Village of Mukwonago
PLAN COMMISSION MEETING
Notice of Meeting and Agenda
Tuesday, June 11, 2019

Date: June 5, 2019

From: Tim Schwecke, AICP; Interim Village Planner

Subject: Malcom Drilling Site Plan / Architectural Review

SITE PLAN

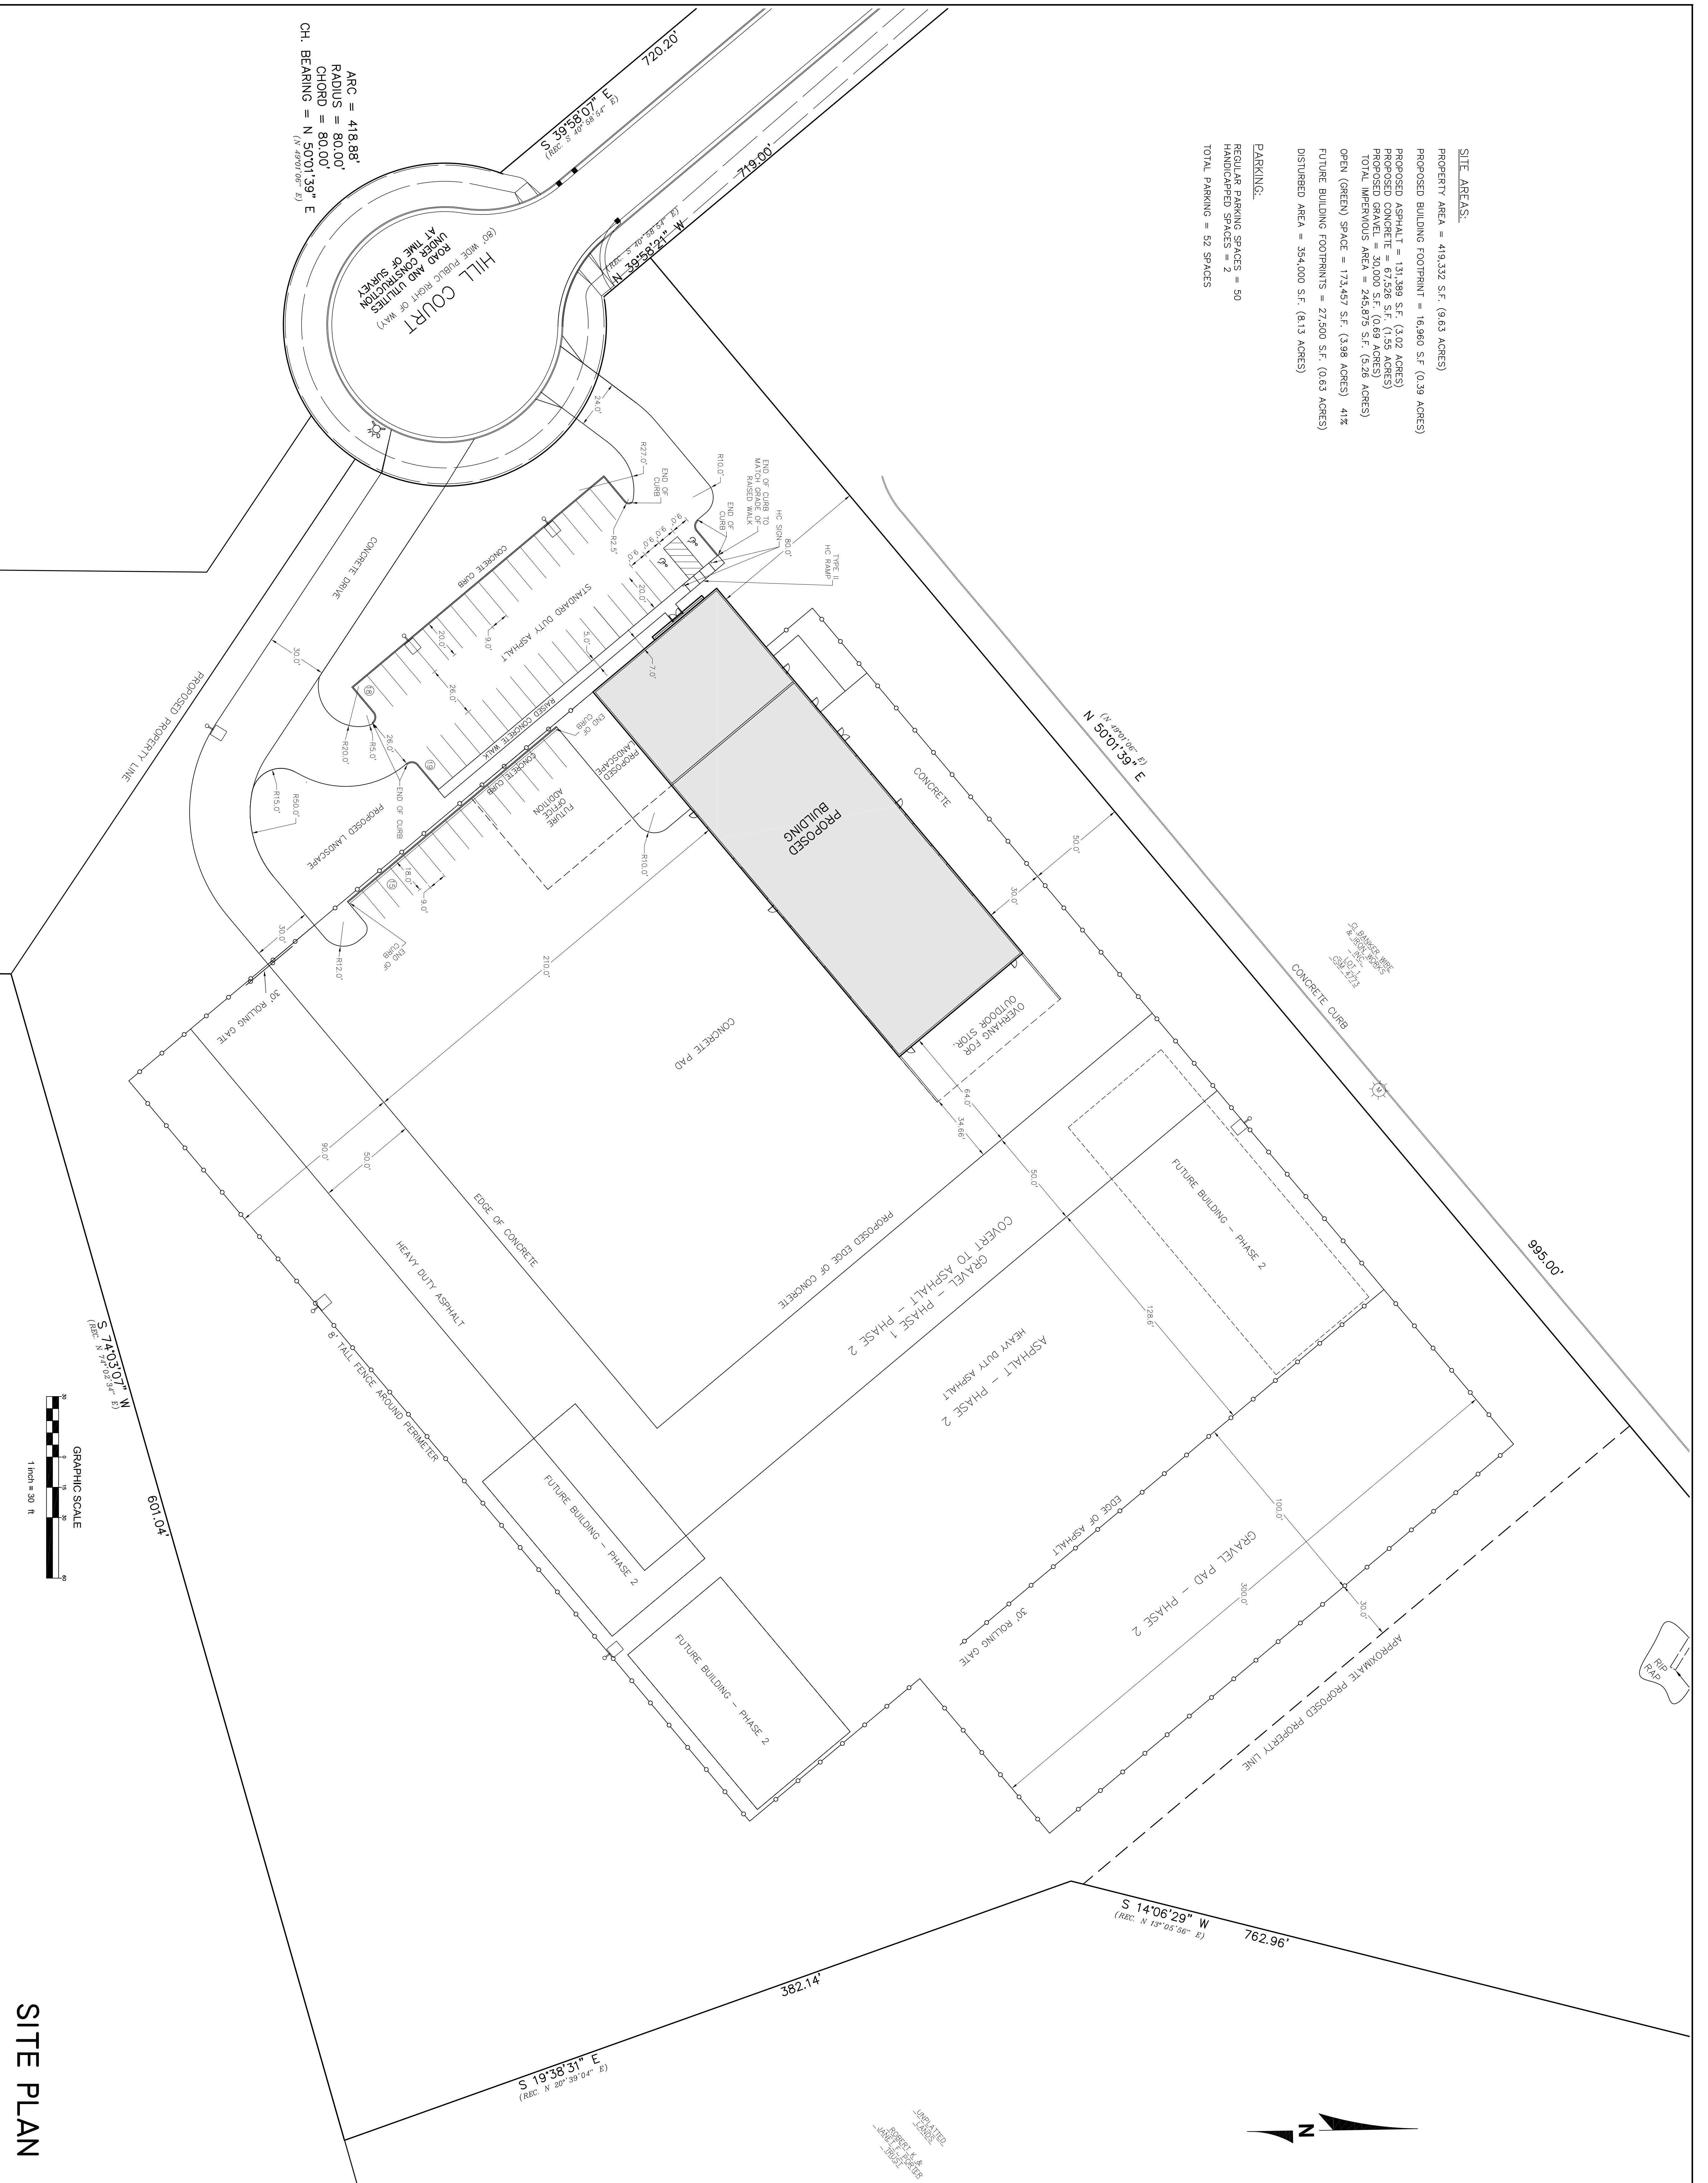
Parking Two parking areas are planned: 37 stalls in front of the building and 16 stalls within the fenced area. Additional parking may be required as part of the building expansion.

As set forth in s. 100-402(f)(5) of the zoning code, all vehicle use areas with parking for 20 or more vehicles on a subject property, must be constructed with full concrete and gutter surrounding the vehicle use areas (both driveways and parking areas). The plan should be revised to meet this standard.

A portion of the yard is intended for long-term overflow storage. It is about 3,000 square feet and is located in the northeast corner of the yard. Given the size of the area and low number of vehicle trips over the area, dust should not be a concern. However, The Plan Commission will need to determine if this area should be hard-surfaced or not.

**SITE GRADING
 AND UTILITY PLAN**

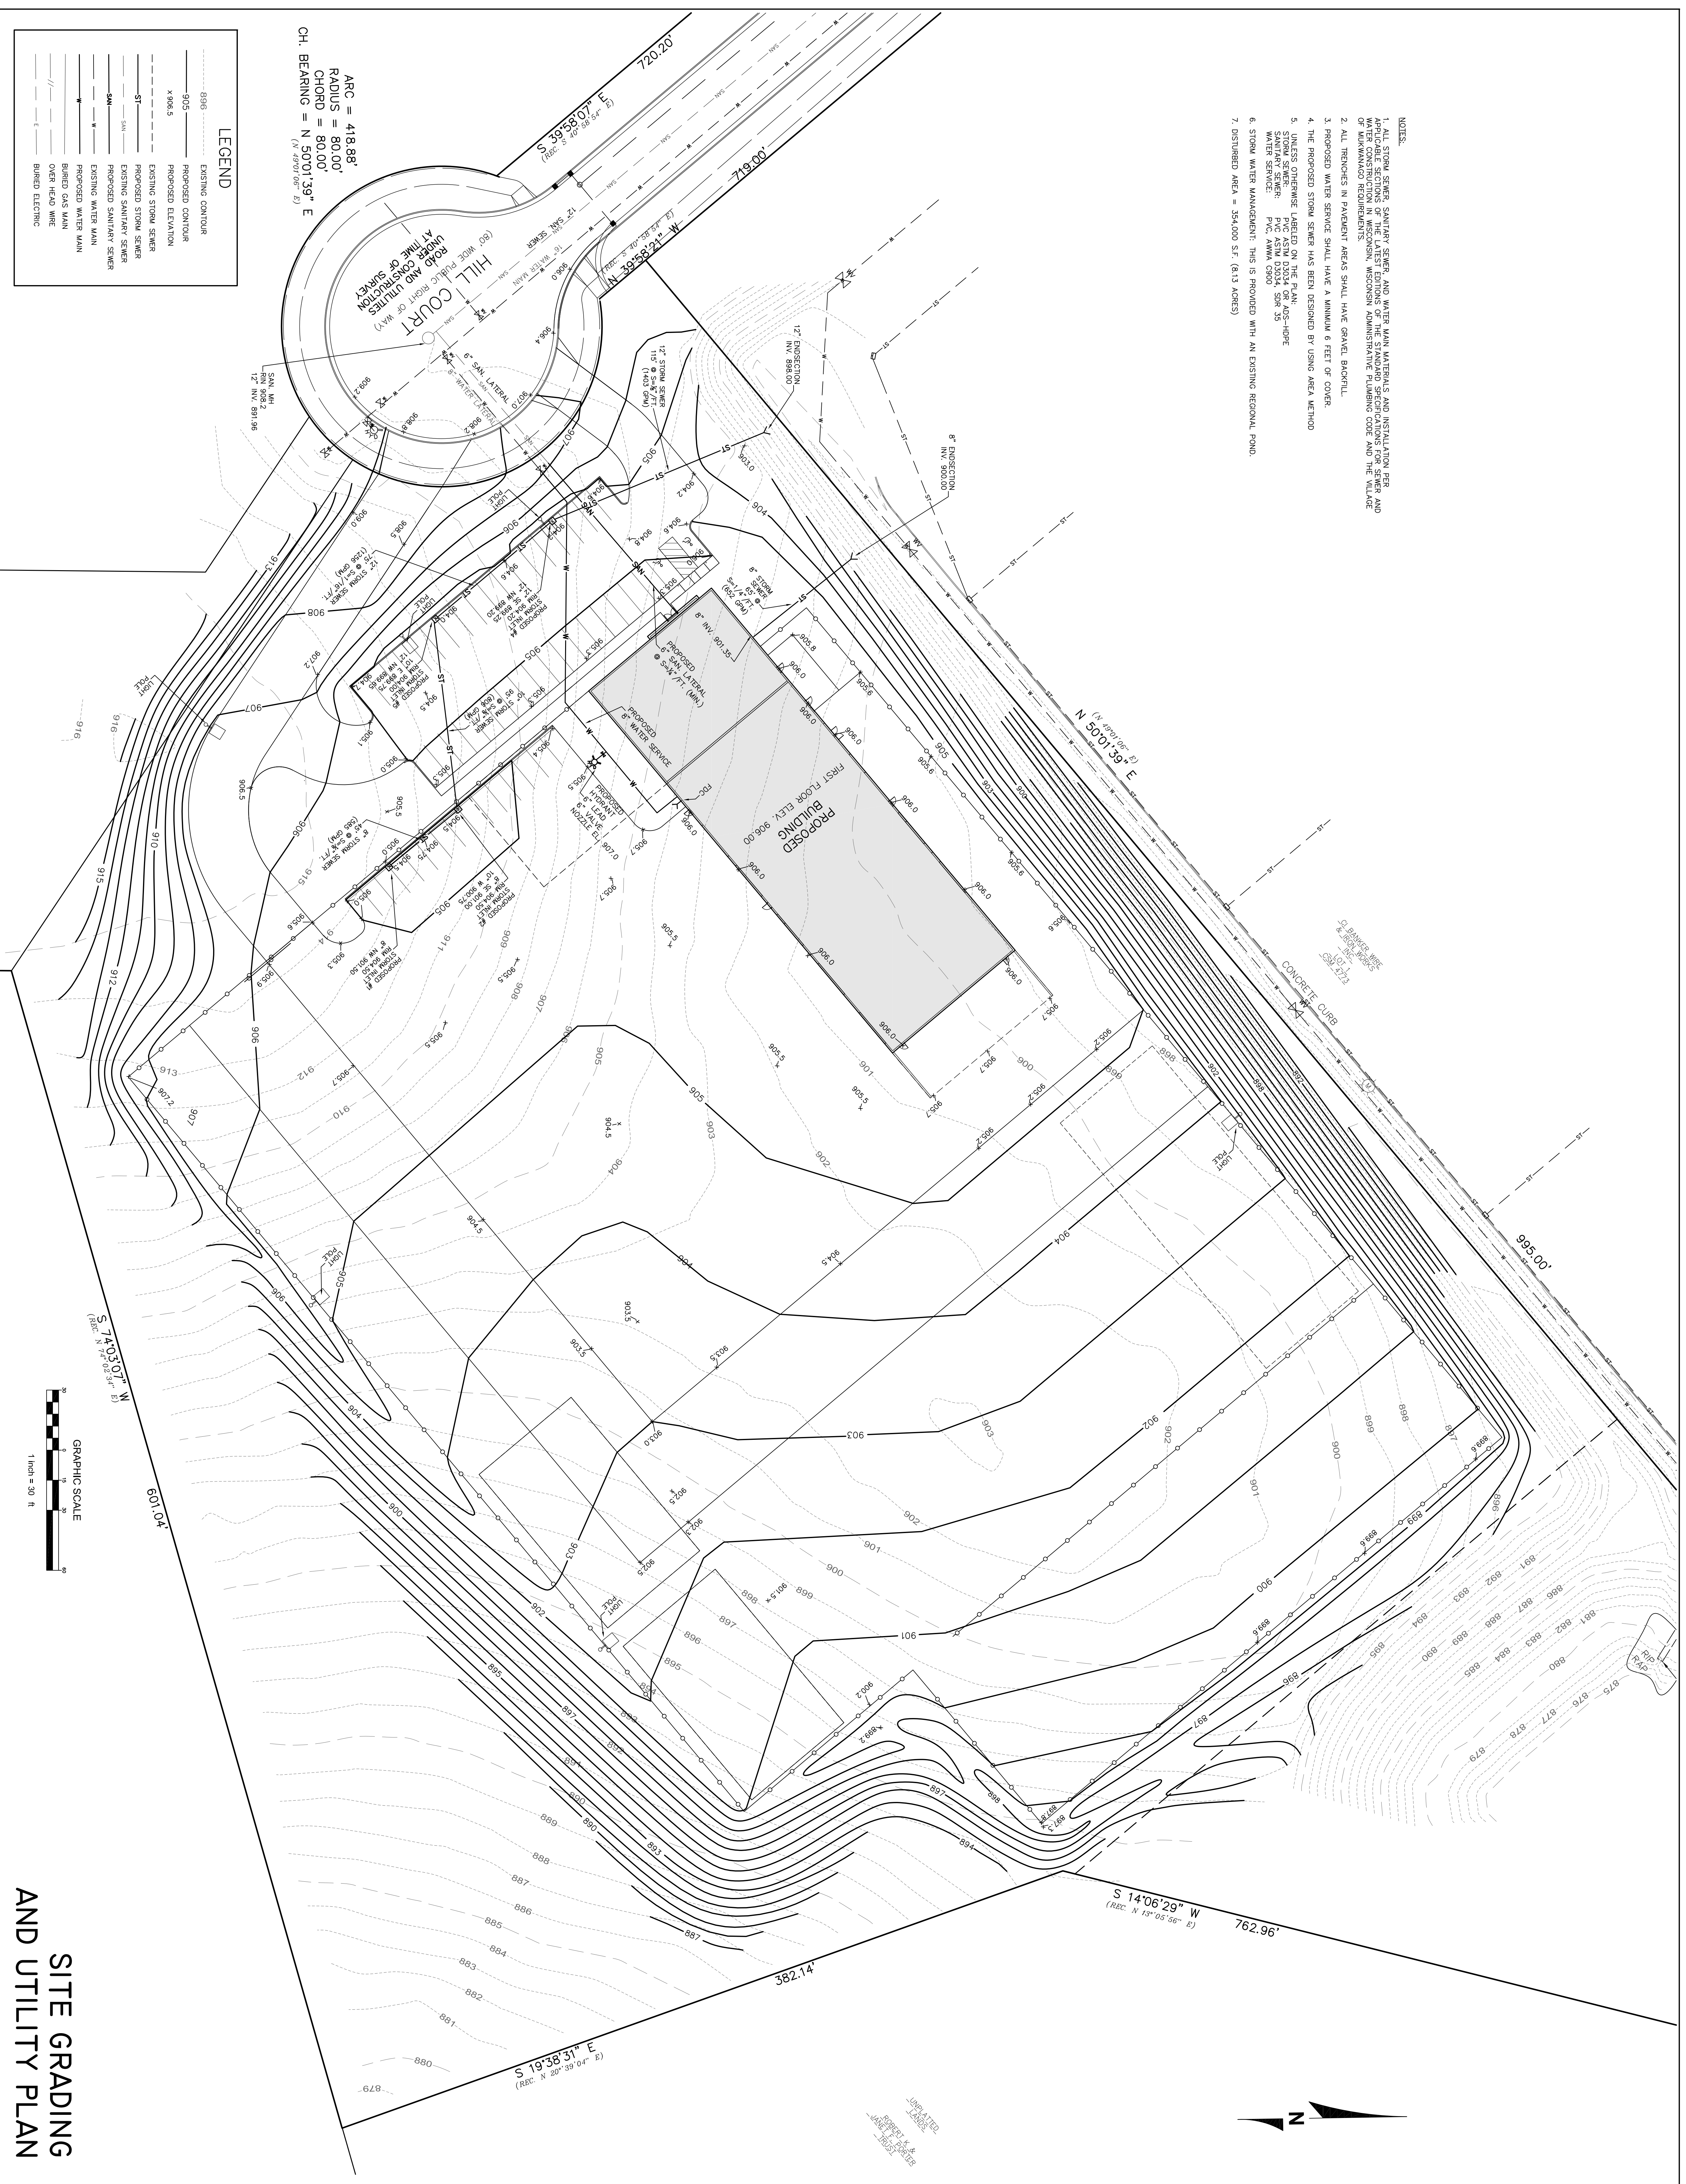
1. Storm sewer and inlet capacity analysis computation should be included on the proposed utility plan.
2. A narrative should be submitted detailing how any spills or leaks of hydraulic fluid, gas, or oil will be handled on the site so that they never make it to the regional pond.
